IN THE MATTER OF RIO ALGOM MINING LLC BHP BILLITON 8950 N. ORACLE ROAD, SUITE 150 TUCSON, AZ 85704 USA	STIPULATION AND CONSENT AGREEMENT
---	--

Attachment A:
"Supplemental Site Assessment to Address Out-of-Compliance Status at Trend Wells RL-1 and
EF-8, Lisbon Facility, REVISED FINAL WORK PLAN"
August 2, 2012

**REVISED FINAL
SUPPLEMENTAL SITE ASSESSMENT TO ADDRESS
OUT-OF-COMPLIANCE STATUS AT TREND WELLS RL-1 AND EF-8
LISBON FACILITY, RIO ALGOM MINING LLC**

Water Resource Consultants FIGURE 6

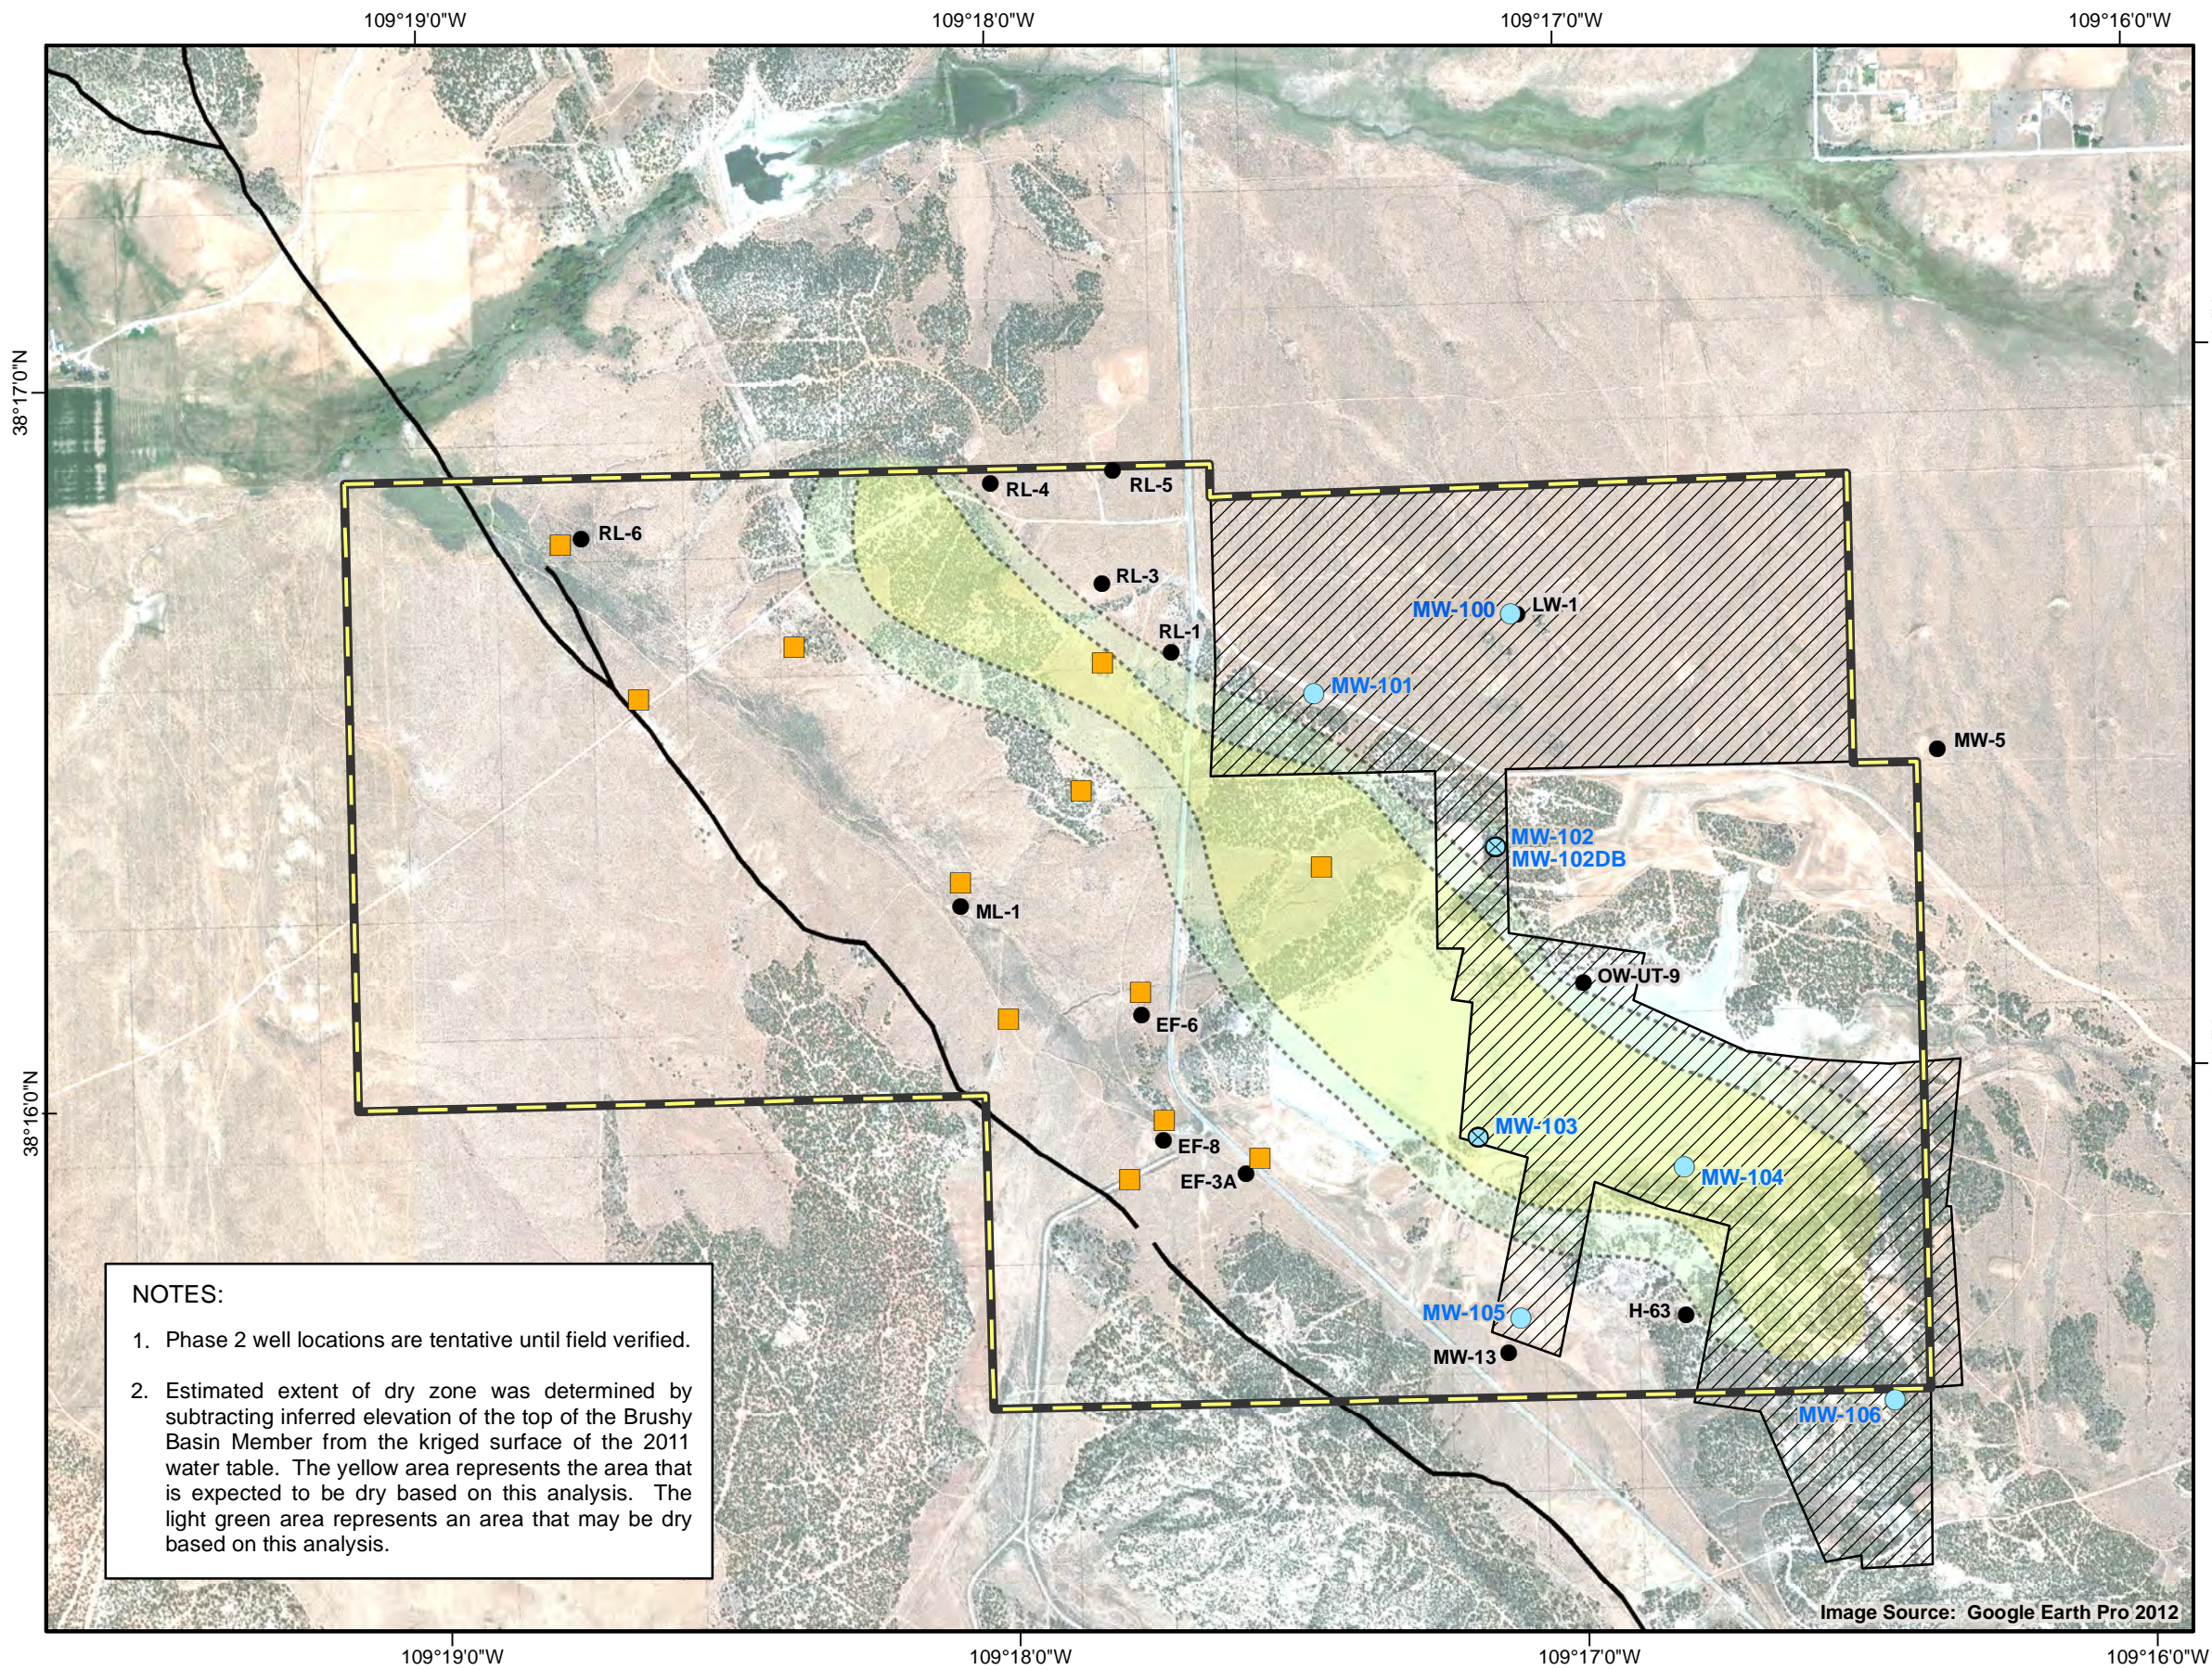
7. A main purpose of creating cross sections is to evaluate assumptions about cross sections across the crest of the LVA; add a well due east of MW-110 (now labeled MW-103) and north-northwest of H-63.	RAML agrees that cross sections will be used to evaluate the extent of saturation across the anticline; RAML agrees to add the requested well for this purpose; this well is identified as well MW-104 in Figure 6 .
